The Commission has issued the enclosed Amendment No. 6, Technical Specification Change No. 16 for License No. DPR-38; Amendment No. 6, Technical Specification Change No. 11 for License No. DPR-47; and Amendment No. 3, Technical Specification Change No. 3 for License No. DPR-55, for the Oconee Nuclear Station, Units 1, 2, and 3. These amendments are in response to your request dated September 20, 1974, and subsequent letters dated October 8, 1974, and October 31, 1974.

DUKE POWER COMPANY

OCONEE NUCLEAR STATION, UNIT 1

AMENDMENT NO. 6 TO FACILITY LICENSE NO. DPR-38,
CHANGE NO. 16 TO TECHNICAL SPECIFICATIONS;

Figure 3.5.2-3A | 16/11/

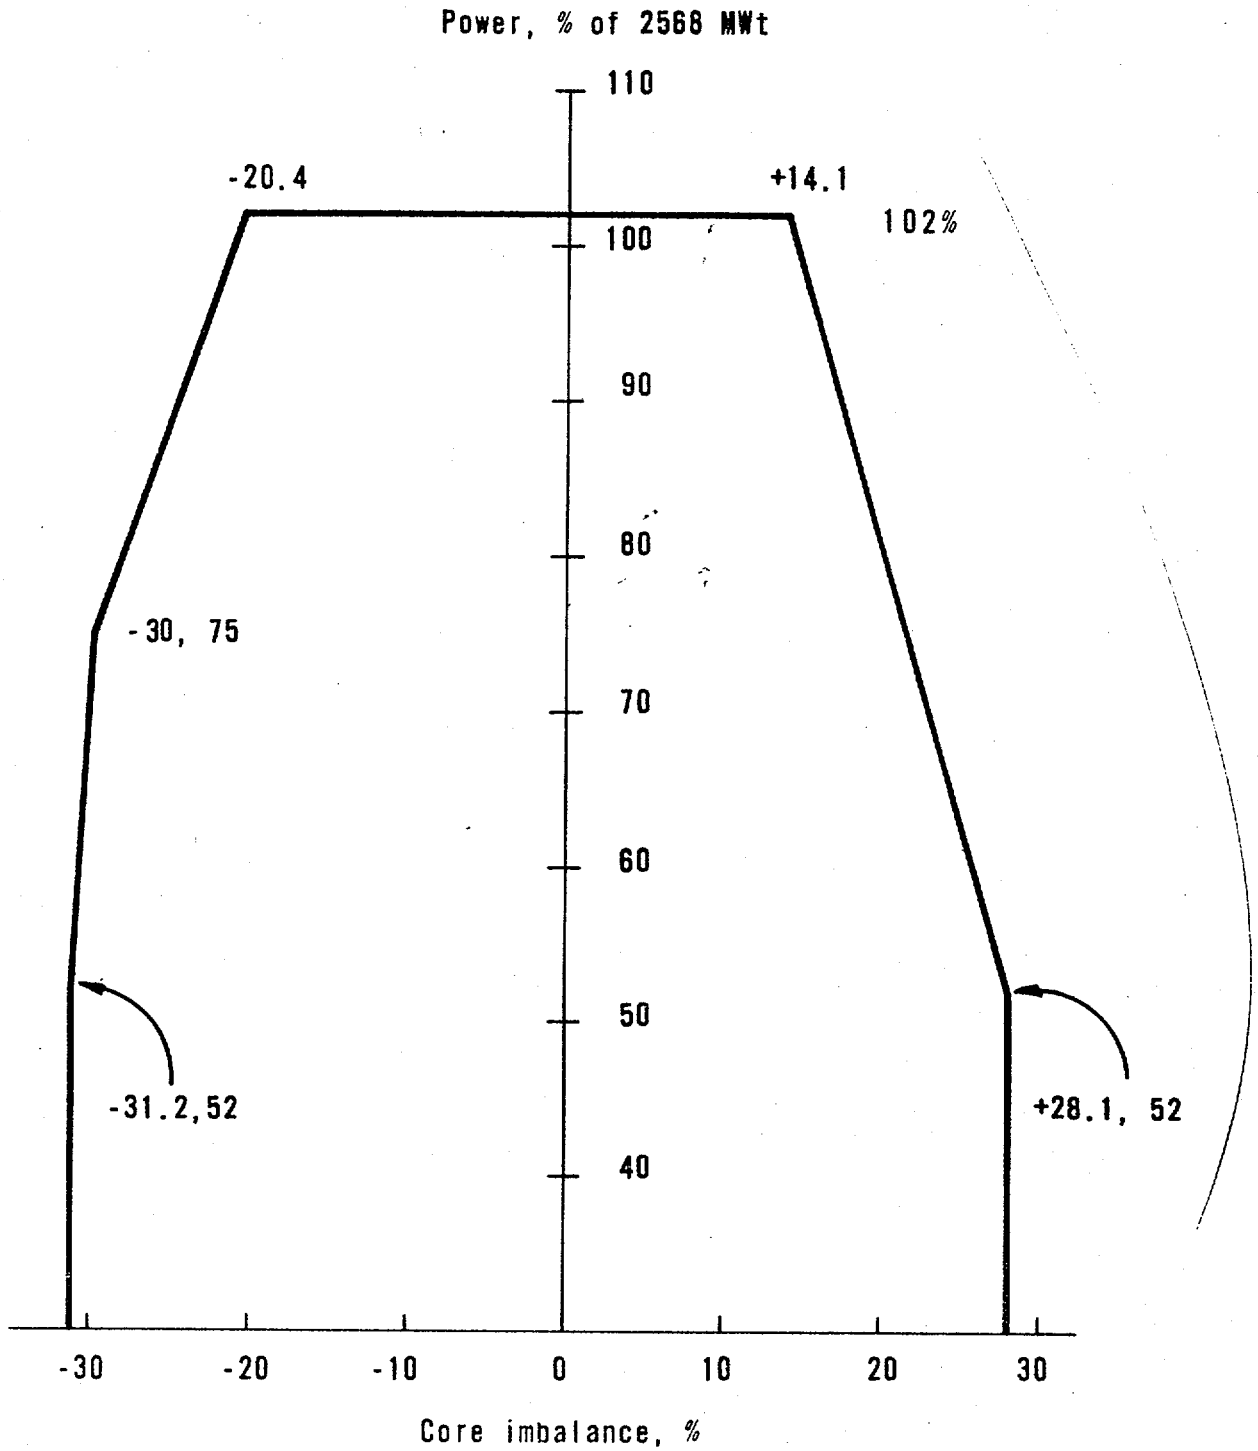
3.5.2.6 Reactor power imbalance shall be monitored on a frequency not to exceed two hours during power operation above 40 percent rated power. Except for physics tests, imbalance shall be maintained within the envelope defined by Figures 3.5.2-3A, 3.5.2-3B, and 3.5.2-3C. If the imbalance is not within the envelope defined by Figure 3.5.2-3A, 3.5.2-3B, and 3.5.2-3C, corrective measures shall be taken to achieve an acceptable imbalance. If an acceptable imbalance is not achieved within two hours, reactor power shall be reduced until imbalance limits are met. 16/11/3

The power-imbalance envelope defined in Figures 3.5.2-3A, 3.5.2-3B, and 3.5.2-3C is based on LOCA analyses which have defined the maximum linear heat rate (see Figure 3.5.2-4) such that the maximum clad temperature will not exceed the Final Acceptance Criteria. Corrective measures will be taken immediately should the indicated quadrant tilt, rod position, or imbalance be outside their specified boundary. Operation in a situation that would cause the Final acceptance criteria to be approached should a LOCA occur is highly improbable because all of the power distribution parameters (quadrant tilt, rod position, and imbalance) must be at their limits while simultaneously all other engineering and uncertainty factors are also at their limits.** Conservatism is introduced by application of:
